D. C. COOK UNIT 1

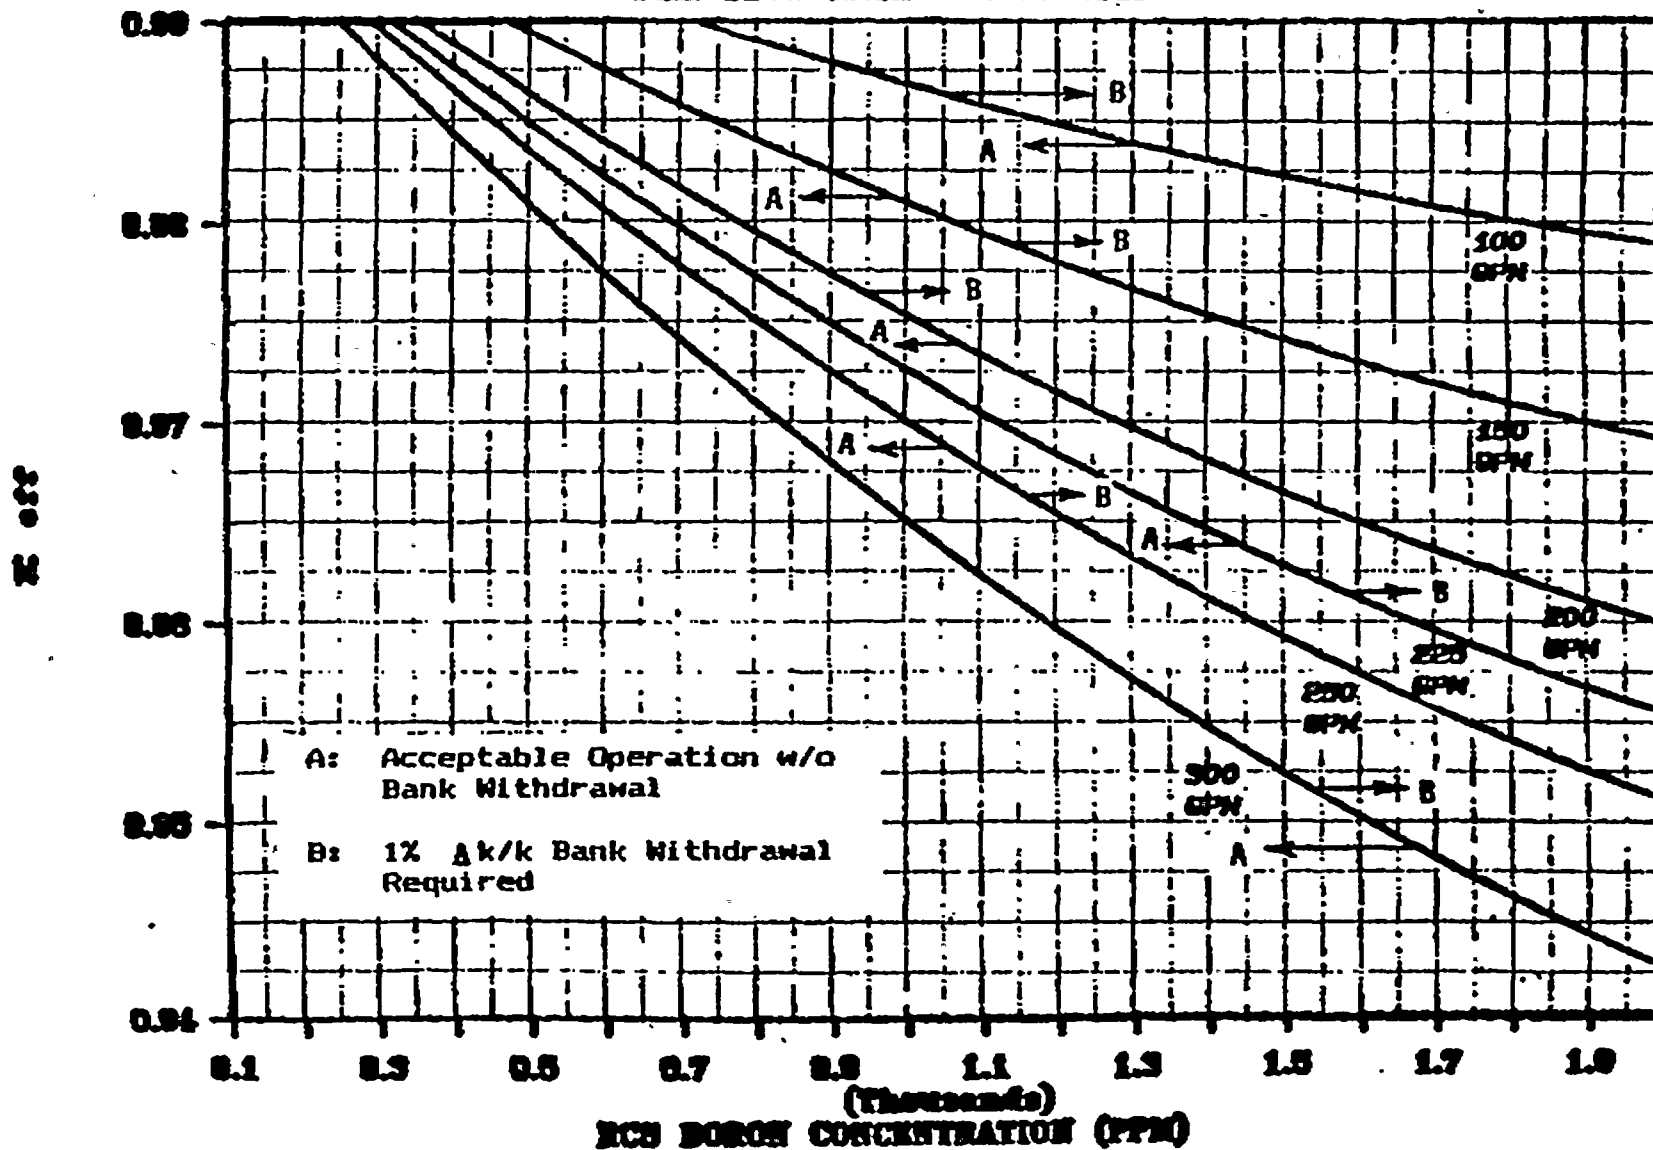
This discussion pertains to a revision of Figure A-1 provided in NS-TMA-2273. The scales of Figure A-1 have been extended to account for increased RCS boron concentrations Modes 4 and 5 (hot and cold shutdown). American Electric Power has indicated that the Mode 5 maintenance level minimum RHR flow rate is 2000 gpm. This is more limiting than the current minimum Mode 4 RHR flow rate of 3000 gpm. As such, the Mode 5 RHR flow rate of 2000 gpm was assumed for this revision. The maximum dilution flow rate is given as 225 gpm on page 14.C-21 (Unit 1) of D. C. Cook FSAR. The D. C. Cook Unit 1 plant specifics, as noted above, have been incorporated in the development of the revised curve.

Figure 1 notes areas of acceptable operation of different dilution flow rates as a function of the RCS boron concentration and borated shutdown margin (K_{eff}). For a given dilution flow rate, if the RCS boron concentration and shutdown margin result in a point placed to the left of the flow rate line, no control rod bank withdrawal is necessary. If the results place the plant to
